Region 6 - Enforcement & Compliance Assurance Division
INSPECTION REPORT

Inspection Dates:	7/28/2025 and 7/29/2025	
Media Program:	Drinking Water	
Regulatory Program(s)	Safe Drinking Water Act (SDWA)	
Company Name:	Duncan Public Utilities Authority – Public Water System	
Facility Name:	Duncan Public Utilities Authority	
Facility Physical Location:	1104 N Waterplant Rd.	
(city, state, zip code)	Duncan, OK 73533	
Mailing address:	1104 N Waterplant Rd.	
(city, state, zip code)	Duncan, OK 73533	
County/Parish:	Stephens County	
Facility Phone Number	580-467-4202	
Facility Contact:	Karl Holtz kholtz@duncanok.gov	Water/Wastewater Superintendent
FRS Number:	110012874693	
System Classification:	Community Water System (CWS)	
PWSID:	OK1010809	
Personnel participating in the inspection:		
Kevin Sarmiento	Eastern Research Group, Inc. (ERG, EPA Contractor) / kevin.sarmiento@erg.com	Inspector
Brynn Goe	ERG / brynn.goe@erg.com	Inspector
Daniel Kim	EPA Region 6 / kim.daniel@epa.gov	Inspector
Karl Holtz	Duncan Public Utilities Authority (Duncan PUA) / kholtz@duncanok.gov	Water/Wastewater Superintendent

Section I – INTRODUCTION

Photograph 1. 7/29/2025 08:47 P7290243.JPG Duncan WTP Backwash Tank
Description: Metal flapper on the end of the overflow line on the backwash supply tank that does not create a proper seal.

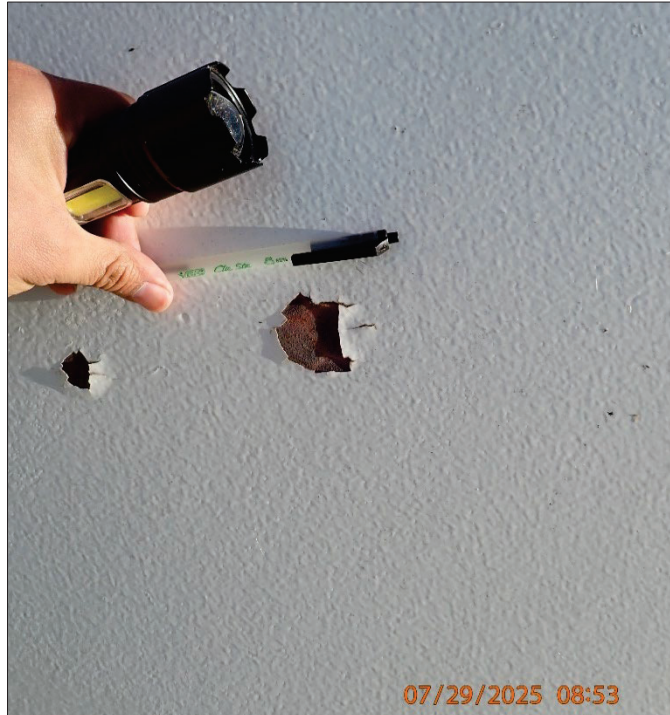
- The metal flapper did not create an adequate seal around the tank overflow line's outlet (Photograph 1).
- A missing seal between the tank ring and concrete foundation exposed gaps extending 17 in. beneath the tank's base in one area (Photograph 2).
- The tank lacked a drain line, requiring a full plant shutdown to perform draining operations.
- Paint was peeling in several areas around the tank (Photograph 3).

Photograph 6. 7/29/2025 08:04 100_0008.JPG Duncan WTP PAC Tank

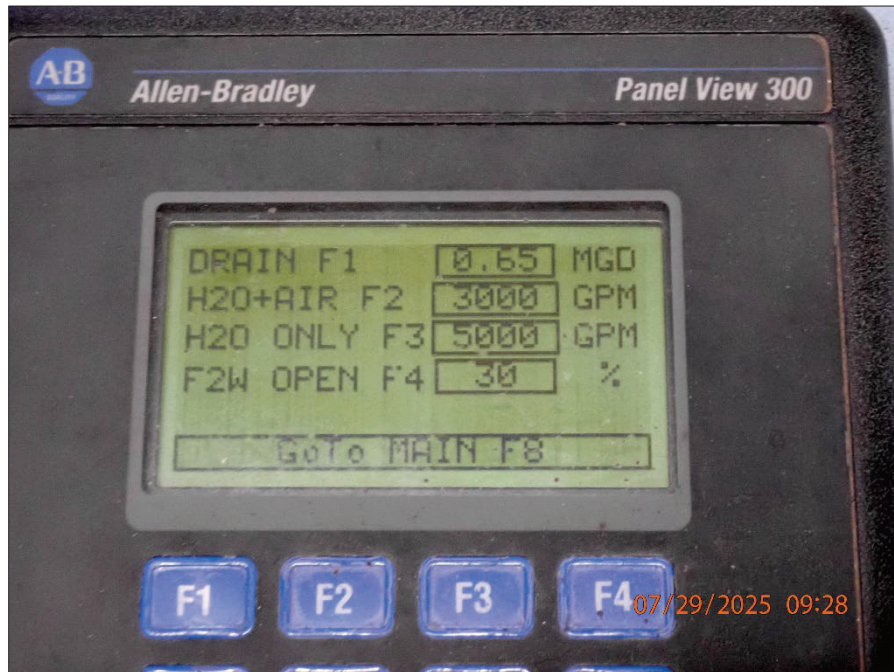
System representatives stated that the System designed and constructed a powdered activated carbon (PAC) hopper to add PAC to raw water for total organic carbon (TOC) removal. After completing the installation, they determined that the hopper did not provide sufficient feed or capacity and subsequently abandoned the project (Photograph 6).

Photograph 12. 7/29/2025 08:57 100_0044.JPG South Plant Filter Gallery

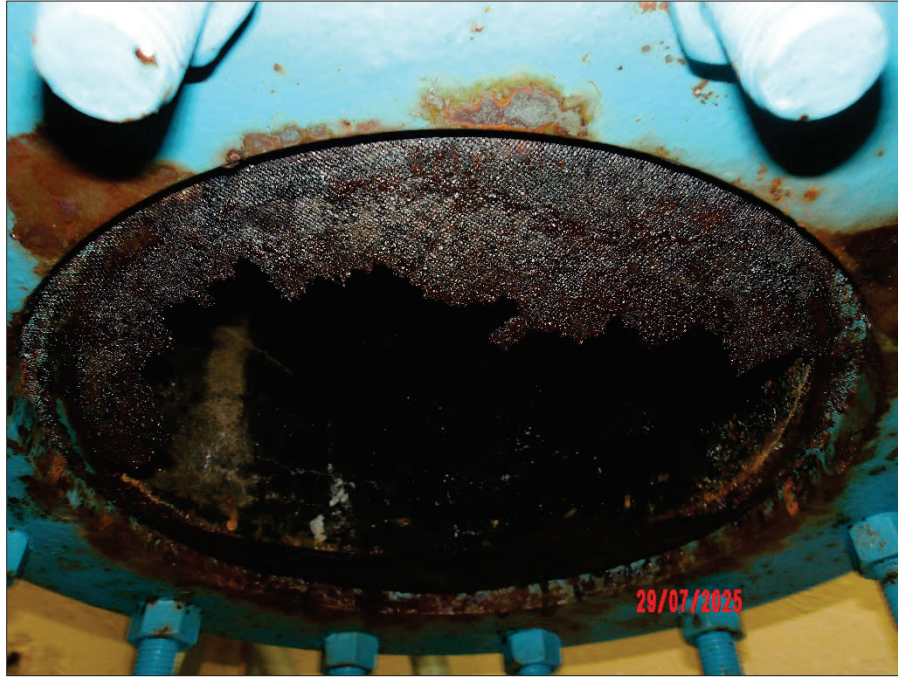
- Stored paint was located in the pipe gallery, adjacent to an access hatch to the 0.5-MG clearwell (Photograph 12).
- One corroded and two completely torn screens were present on the 0.5-MG clearwell's air vents (Photograph 13 and Photograph 14).
- A clearwell sampling line passed through an unprotected opening in the floor of the filter gallery, leading directly to the interior of the South clearwell below (Photograph 15 and Photograph 16).
- A crack on the exterior wall of the South Filter Building, adjacent to filter 6, was actively leaking (Photograph 17 and Photograph 18).

Photograph 29. 7/29/2025 10:39 P7290448.JPG Ammonia Storage Room

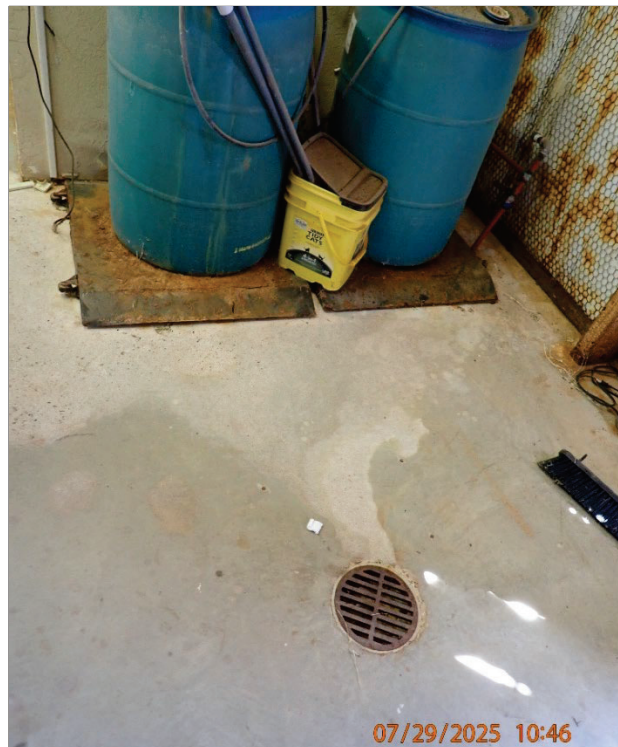
- One propane tank and one ammonia tank were not chained (Photograph 28 and Photograph 29). System representatives stated that they were uncertain if the tanks were empty.

Photograph 46. 7/29/2025 13:13 P7290526.JPG ACH and Caustic Chemical Building

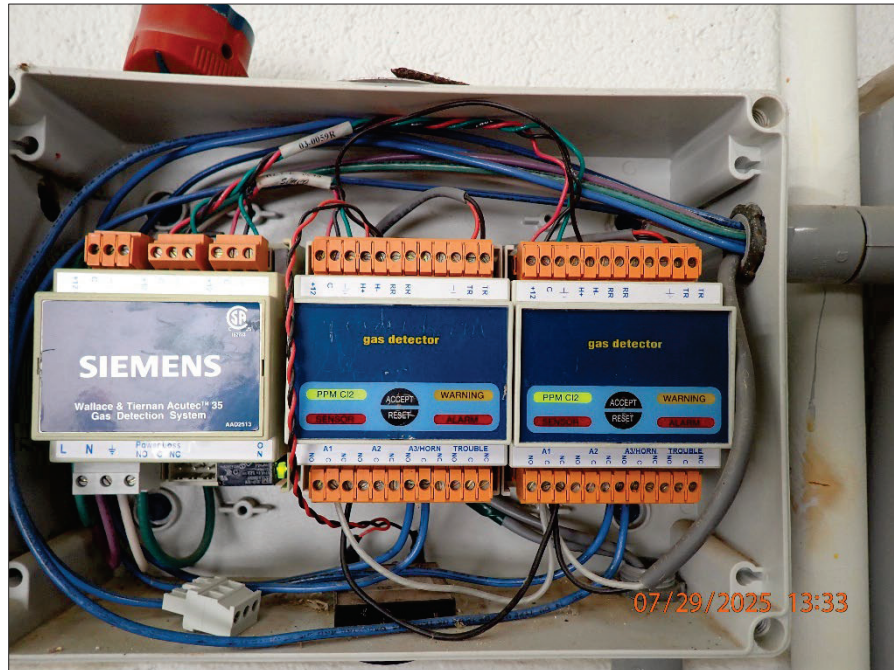
Area of Concern 31. The EPA inspection team observed garden hoses without vacuum breakers at the South Plant filter (Photograph 9), WTP polymer storage and feed room (Photograph 50), and WTP Caustic and ACH storage building (Photograph 46). The System also had threaded hose-bibs without vacuum breakers at the Northwest Sector Tower (Photograph 76) and the rest of the South Plant filters.

Photograph 60. 7/28/2025 15:11 P7280187.JPG 10th and Elk Pumphouse

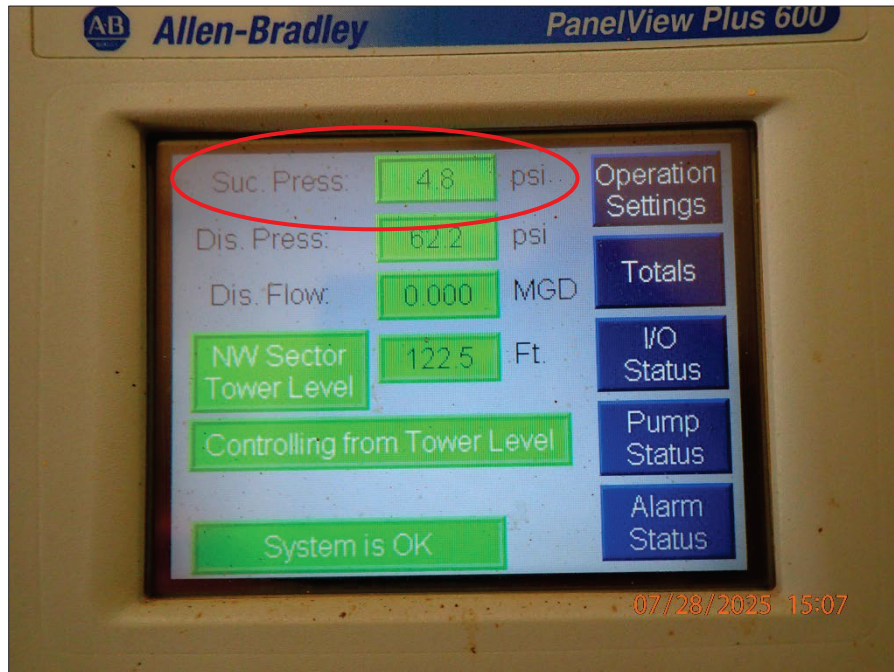
- An air relief valve lacked a 24-mesh corrosion-resistant screen on the end of the down-turned pipe (Photograph 60).
- A pressure of 4.8 pounds per square inch (psi) was recorded on the suction side of the booster pump. (Photograph 61). According to system representatives, the combined pressure from the booster pump and the elevation of the tank typically provide an average of 54 psi to the system.

OAC 252:626-19-1(e) “Locate air relief valves at high points in lines where air can accumulate. Do not use automatic air-relief valves where flooding of the valve exhaust may occur. Locate sufficiently sized blow-offs at low points of large mains to effectively remove accumulated sediments. Extend the open end of the exhaust line from automatic valves to at least 1 foot above grade and terminate with a screened, downward-facing elbow. Do not connect air reliefs or blow-offs directly to any sewer.”
